PROJECT NAME: BRADFORD - RYEGATE  
PROJECT NUMBER: IM MEMB(16)

FILE NAME: 08-Conc Remov Plan.dgn PLOT DATE: 2/25/2009  
PROJECT LEADER: JPB DRAWN BY: MWS  
DESIGNED BY: SRB CHECKED BY: JPB  
**BITUMINOUS CONCRETE REMOVAL PLAN** SHEET 7 OF 61

**BITUMINOUS CONCRETE REMOVAL & REPLACEMENT PLAN**

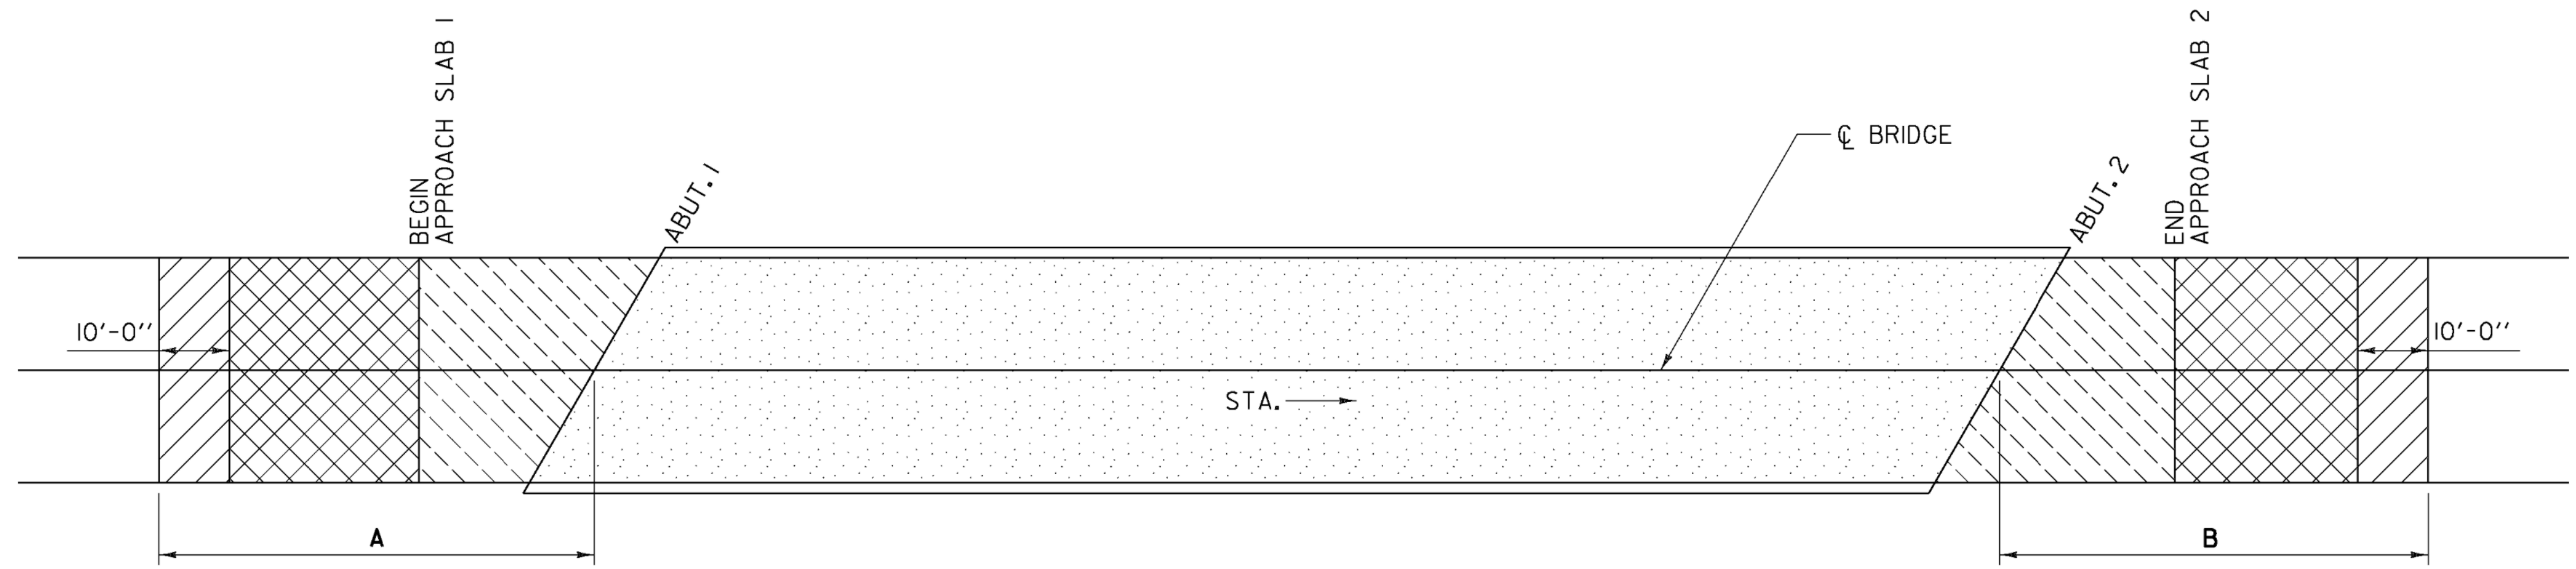
BRIDGE NO.	A(FT)	B(FT)
59S	80.0	80.0
60S	100.0	<del>60.0</del> 100.0
64N	60.0	60.0
64S	80.0	<del>60.0</del> 80.0
67N	80.0	80.0
69N	60.0	80.0

COLD PLANED +175' BETWEEN BRIDGES 59S & 60S TO ELIMINATE (2) PAVING JOINTS (1 1/4" DEPTH). EL TO EL TO RETAIN RUMBLE STRIPS.
